**SUNDRY NOTICES AND REPORTS ON WELLS**  
*Do not use this form for proposals to drill or to re-enter an abandoned well. Use form 3160-3 (APD) for such proposals.*

8. Well Name and No.  
GRAYBURG DEEP 25 FED 5

9. API Well No.  
30-015-03083-00-S1

\*\* BLM REVISED \*\*

WELLBORE SKETCH  
 ConocoPhillips Company -- Permian Basin Business Unit

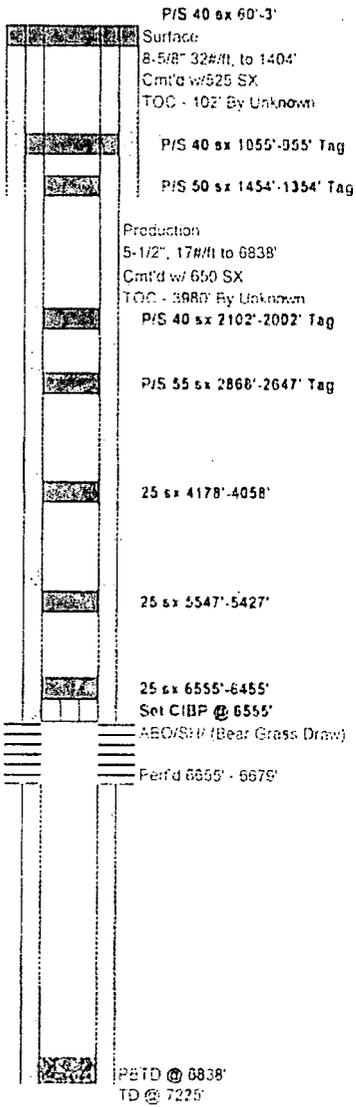
On 2012 2/10?

SA 2747 ✓

GL 4178 -

ABO 6560 6551 -

- 1) MIRU  
2) POOH & LD Prod equipment  
3) RIH WL - Set 5-1/2 CIBP @ 6555'. Circ hole w/ MLF. Cap BP w/ 25sx cmt to 6455'  
4) Spot 25sx cmt @ 5547' - 5427' 150' plug min.  
5) Spot 25sx cmt @ 4178' - 4058' 4228', spot 25 SX from 4030-3880. WOC Tag (DVT)  
6) Perf & Sqz 55sx cmt @ 2868' - 2647'. WOC-Tag  
7) Perf & Sqz 40sx cmt @ 2102' - 2002'. WOC-Tag 120' plug min.  
8) Perf & Sqz 50sx cmt @ 1454' - 1354'. WOC-Tag  
9) Perf & Sqz 40sx cmt @ 1055' - 955'. WOC-Tag 925' - 825'. Perf @ 475, sqz cmt to 375. WOC Tag (T-SALT)  
10) Perf & Circ 40sx cmt @ 60' - 3'  
11) Verify cmt @ surface. RDMO. Clean location, cut off WH & anchors. Install P&A marker.
